12.3 State Development Assessment Unit referral for Proposed Residential Apartments and Commercial Tenancy

The purpose of this report is for Council to form a recommendation to the Western Australian Planning Commission (WAPC) with respect to the development application for the mixed-use proposal comprising a 16 storey tower with 85 multiple dwellings and a ground floor commercial tenancy, at Nos. 167 and 169 Bank Street, East Victoria Park.

That Council advises the Western Australian Planning Commission that the development application for the proposed Mixed-Use development at Nos 167 and 169 Bank Street, East Victoria Park is not supported for the following reasons:

Above: Annotated elevation depicting interface of proposed balconies onto/above adjacent residential properties.

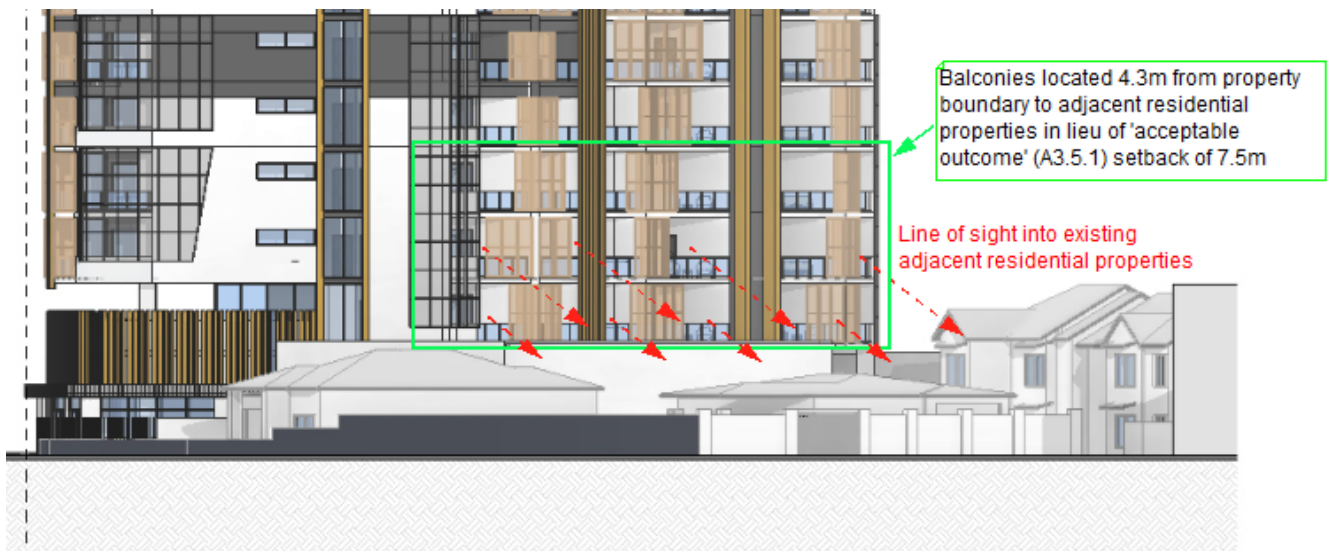
15. One example of the above is the applicant's description of visual privacy setbacks (A3.5.1) as 'compliant' despite open balconies being located as close as 4.3m from the adjoining residential property boundary and the 'acceptable outcome' setback for that interface being 7.5m.

The applicant describes visual privacy setbacks (A3.5.1) as 'compliant' despite open balconies being located as close as 4.3m from the adjoining residential property boundary and the 'acceptable outcome' setback for that interface being 7.5m. The adjacent dwellings located at Nos 64, No 66 (a & b) and No 68 Oats Street would have their back yards overlooked by the proposed development.
